SUBSURFACE WASTEWATER DISPOSAL SYSTEM APPLICATION

Street or Road: 380 Pleasant Avenue

Replacement System Variance Request

SUBJECT: Approval, Replacement System Variance Request, Axiotis property, Peaks Island

SUBSURFACE WASTEWATER DISPOSAL PLAN

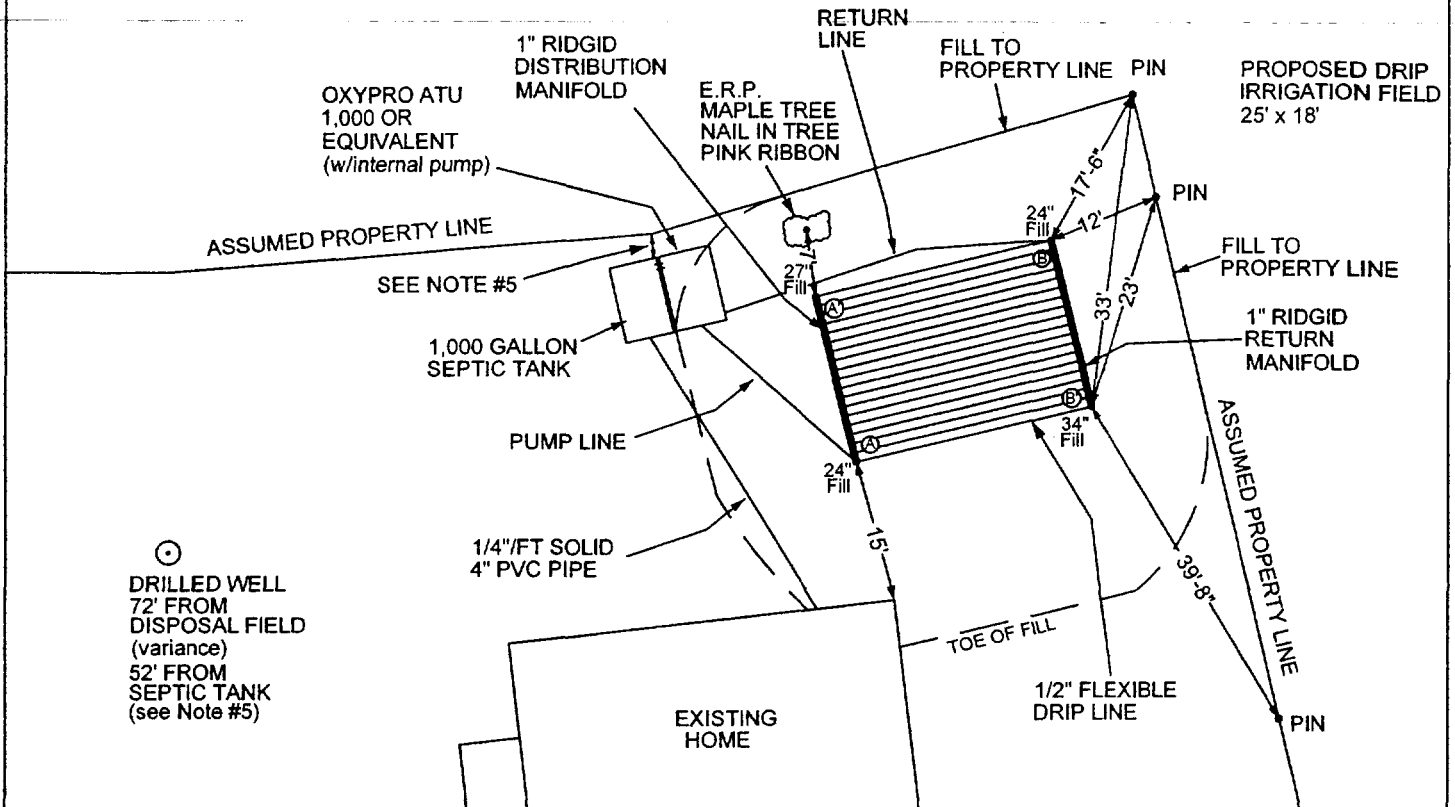
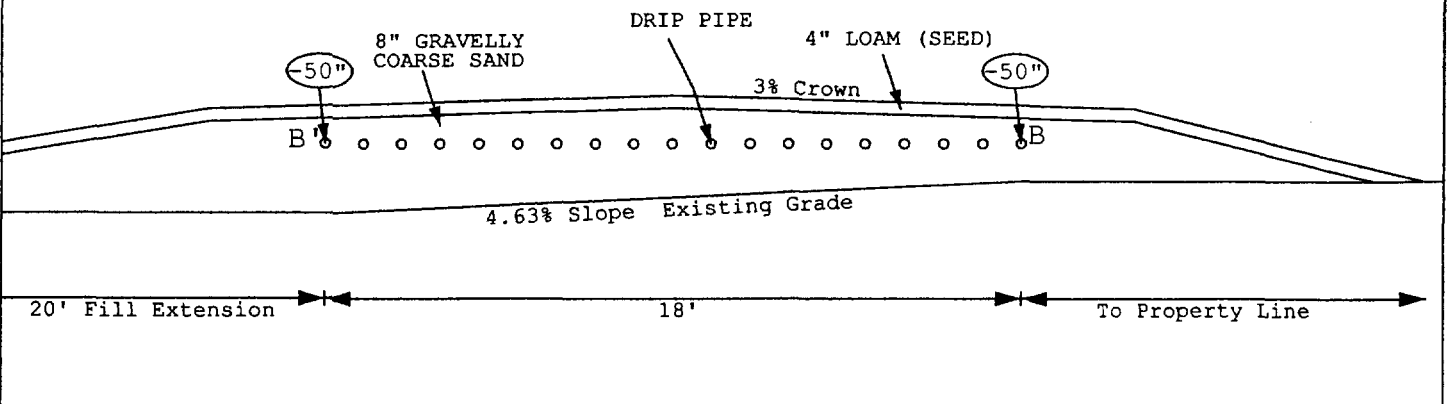
Comments: No PRACTICAL LOCATION FOR TANK

2. Existing well is 72' from the proposed disposal field (requires variance approval from the Local Plumbing Inspector (LPI)). Resident of home, Sophia West, was notified that the proximity of the well to the disposal field might increase the potential of well contamination.

The Division has reviewed a replacement system variance request for the subject property. The state variance requested is to install the system with a setback distance reduction from your well to the disposal field of 72 feet, a setback distance reduction from a slab, frost wall, or columns to the disposal field of 14 feet, a setback distance reduction from a property line to the septic tank of 0 feet, a reduction in depth to the seasonal high ground water table from 12 inches to 0 inches, a reduction in depth to bedrock from 24 inches to 1 inch, and a fill extension grade to 3:1 as needed to keep fill from crossing the property lines. As we understand the situation, the variance request has been submitted because topography and existing development limit the potential system location. The system design prepared by Andrew Gobeil, SE, dated 09/18/2005 is otherwise found to be in compliance with the Maine Subsurface Wastewater Disposal Rules.

We approve the requested variance with the following requirements:

1. A permit for system installation is to be obtained from the Local Plumbing Inspector in advance of the start of system construction.
2. The system is to be installed in accordance with the submitted and approved system design. Should alterations to the design be required at the time of construction, the site evaluator is to be notified prior to making any changes.
3. The contractor is to scarify the soils under the fill extensions to create a transitional zone more compatible with the disposal field area.
4. The septic tank to be installed shall be monolithic.
5. No fill shall cross over the property lines unless a legal easement is granted by the abutting property owners.
